**PLANNING COMMISSION AGENDA  
CITY OF PRAIRIE VILLAGE  
TUESDAY, OCTOBER 7, 2025  
7700 MISSION ROAD  
COUNCIL CHAMBERS  
6:00 P.M.**

**TO:** Prairie Village Planning Commission  
**FROM:** Chris Brewster, Multistudio, Planning Consultant  
**DATE:** October 7, 2025 Planning Commission Meeting

**Request:** Site Plan - Exception to Neighborhood Design / Windows

1 SOUTH (REAR) ELEVATION  
SCALE 1/4" = 1'-0"

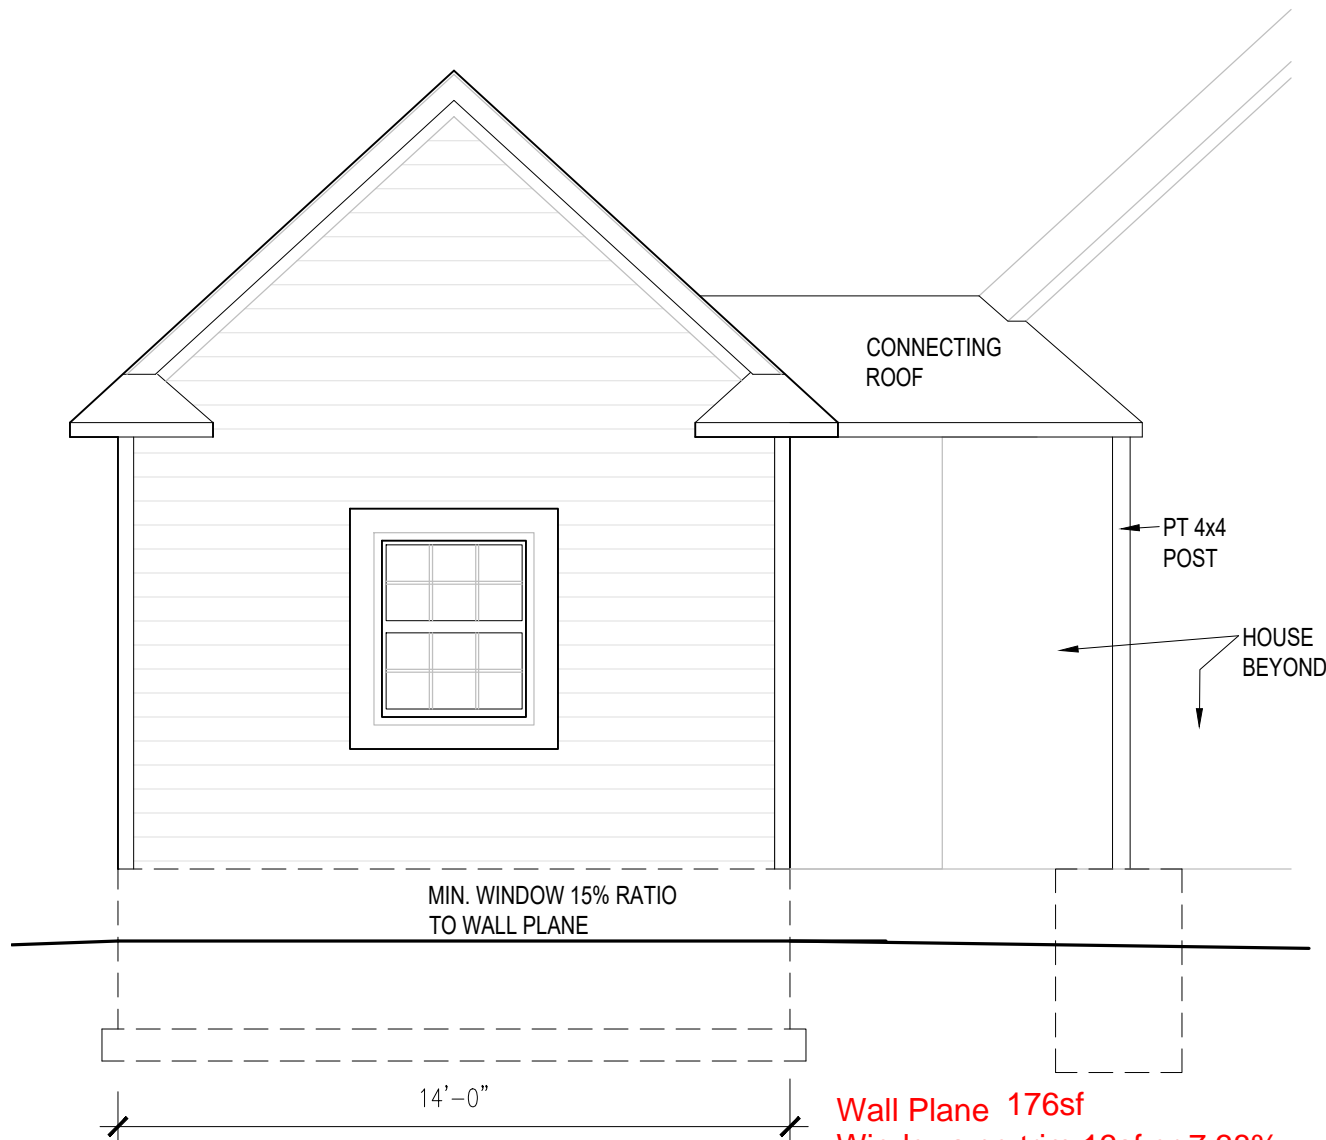
This plan is for a detached outbuilding. While accessory structures are generally not subject to the neighborhood design standards (and major accessory buildings are only subject to a general compatibility standard with the principal building), the proposal to attach this building to the principal building by a covered walkway subjects it to principal building standards. Additionally, since the elevations of the outbuilding are offset by more than 12 feet from the principal building, each elevation of the outbuilding must meet the design standards independently. Specifically, this means that the rear elevation must have 15% windows and the side elevation must have 8% windows. The south (rear) elevation includes a 13 square foot window on a 176 square foot elevation, which is 7.38% of the elevation. Up to 3% addition can be counted with the window and trim, but this brings the eligible percentage to 10.38% rather than the required 15%. [The window and trim is 22 square feet, and 12.5% of the elevation, but only up to 10.38 contributes to the requirement per the ordinance.]

1. The exception is limited to the plans included in the application.
  2. The exception is subject to an associated variance request (cumulative side yard setback) being approved by the BZA.
  3. The applicant receives all further necessary permits from Public Works and the building official demonstrating compliance with all other applicable standards, including the lot impervious cover standards being consistent with and within the parameters of an exception granted by the Planning Commission in PC 25-05.
-
